June 2, 2006

Re: Lee County Groundwater Resource & Mining Study
Wellfield Protection & Mine Pits

Figure 2 – University Lakes Mine

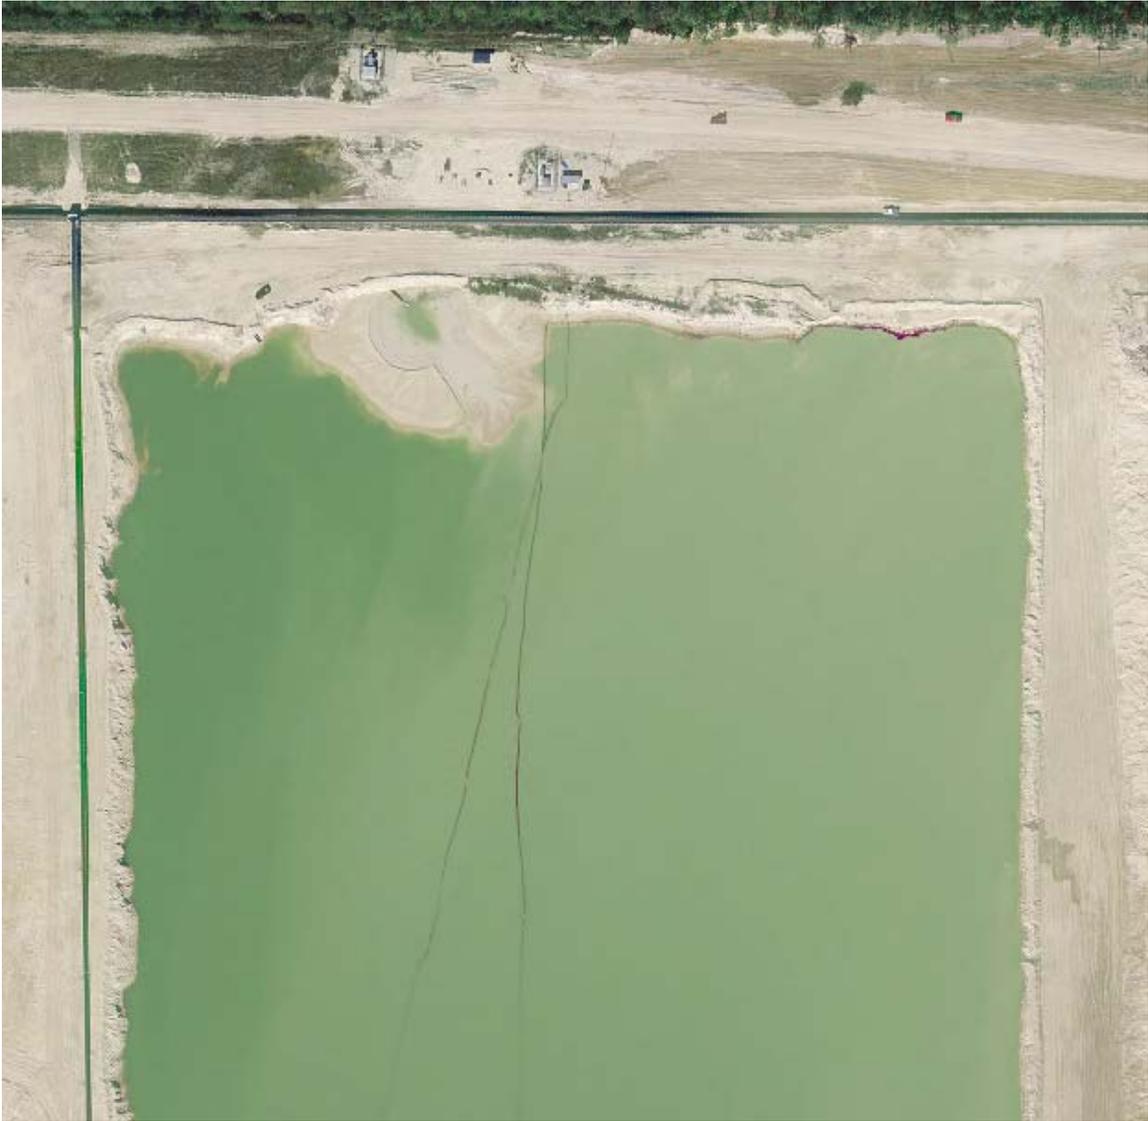
When we were reviewing the Lee County 2005 aerial photographs of the University Lakes Mine to determine how best to update the mine database and groundwater flow model, we noticed an area of contamination. I have attached a series of four aerial photographs (figures 1 through 4). In the figure 1 the University Lakes Mine is visible in the northern half of the figure and the Corkscrew Water Treatment Plant and Wellfield are visible in the southern half. In each progressive figure, they zoom in on the contamination plume that seems to be hydraulic fluid seeping into the pit from the northern shoreline. In the case of a large release of contaminants through rapid surface water dispersion and proximity to the wellfield, it is possible that detectable contaminate levels could quickly migrate into potable water supply wells.
